PIPE LINE NEWS

Model OP10 Valve

Change to Handle Lever box and Spring cap

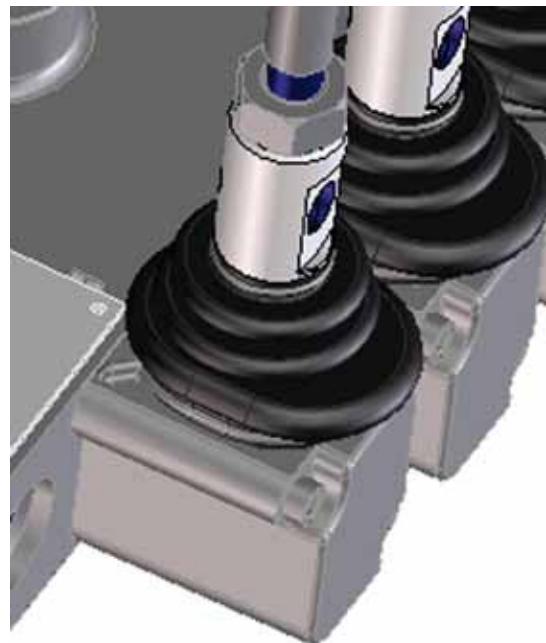
The current alloy castings utilised on the lever box and spring cap are being replaced with updated designs manufactured in glass reinforced nylon. The new components are backward compatible with the OP10 valves in the field. However it is necessary to fit a complete new lever box assembly including shift legs, pins, rubber boots, and socket head cap screws. All items will be supplied in a retrofit package.

- Can be used in underground mine applications
- New design rubber boot utilises a higher grade of material
- Rubber boot retained on lever box by metal clip to reduce ingress of high pressure water
- Tighter manufacturing tolerances on new lever box facilitate better mounting location
- New materials help to contain manufacturing costs
